TOWN OF LAKEVILLE MEETING POSTING & AGENDA

Name of Board or Committee:	Zoning Board of Appeals
Date & Time of Meeting:	Thursday, July 28, 2022 at 6:00 p.m.
Location of Meeting:	Lakeville Public Library 4 Precinct Street, Lakeville, MA 02347
Clerk/Board Member posting notice:	Cathy Murray

Huerth hearing – 8 Edgewater Drive – request for a **Special Permit** under 6.1.3 and 7.4 to add to a second floor and modify the roof of a pre-existing non-conforming structure, located on a pre-existing, non-conforming lot.

5. TAC VEGA MA Owner, LLC hearing, continued – 310 Kenneth W. Welch Drive – request for a **Variance** under 5.1 and 8.2.2 to allow the lot coverage to exceed the maximum allowed with a density bonus of 70% by 3%, for a total of 73%.

8 Edgewater Drive

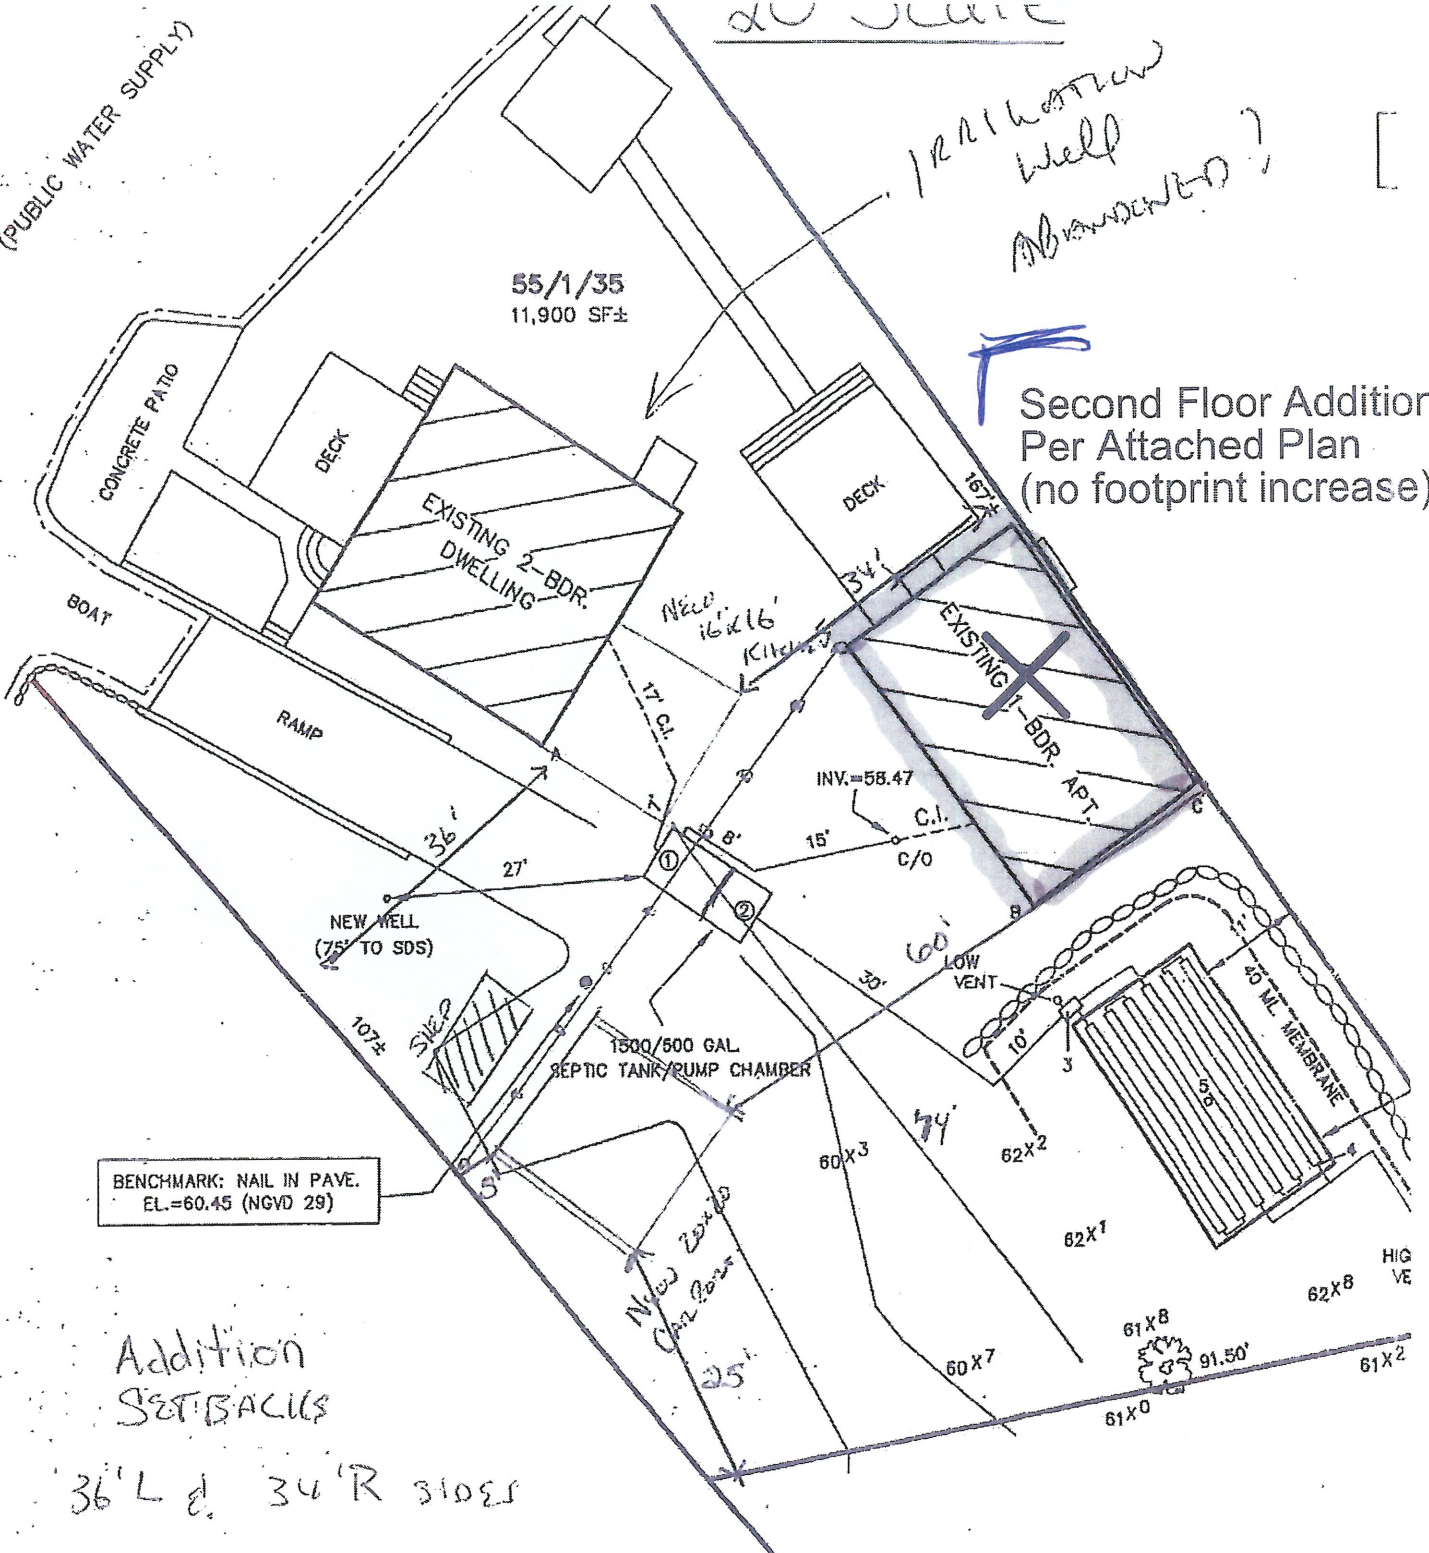
We received a copy of the Petition for Hearing for 8 Edgewater Drive. The sketch shown is from an As-built plan dated 7/16/12, which is not up to date. The septic tank was relocated in March 2021, and an as-built plan has never been submitted showing the new location of the septic tank. Since the property is not in compliance, the Board of Health recommends that the applicant submit an as-built plan to the Board of Health to bring it into compliance before issuing an approval.

Board of Health

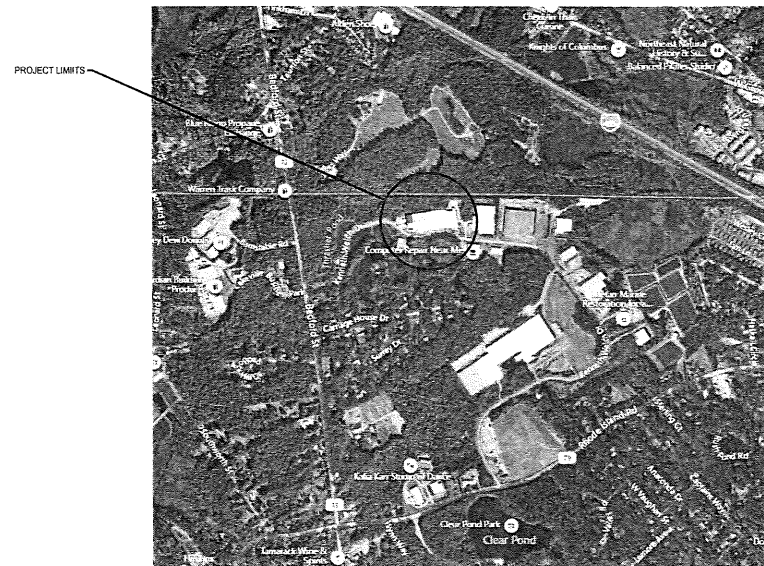
Mr. Olivieri clarified that the 3% is then needed to comply with the Planning Board's request to eliminate the parking problem. He then read comments from the Town Boards into the record. The June 6, 2022, letter from the Board of Health stated they were concerned with the grading in the parking area over the leaching area. A grading plan proposed removing more than 1.58 feet

rendering the field unusable. The Board of Health requests a plan be submitted showing the elevation of the existing septic system and the proposed grading to ensure the existing septic system is not altered. The Board objects to any change that would alter the existing septic system. The June 13, 2022, letter from the Conservation Commission stated that due to the extensive wetland areas within the 100' buffer zone and the nature and extent of the disturbed area, the Commission will require the submittal of a Request for Determination of Applicability. The June 13, 2022, memo from the Planning Board recommended the Zoning Board continue this petition hearing until after the Planning Board has received a satisfactory site and landscape plan.

The existing septic system northwest of the building has existing surface elevations ranging from 54.00 to 54.50. In that area of the site, Epstein is matching existing grades as close as possible. Proposed grades over the septic field range from 54.17 to 54.60. So, no material is being removed and the septic field should function as originally designed.
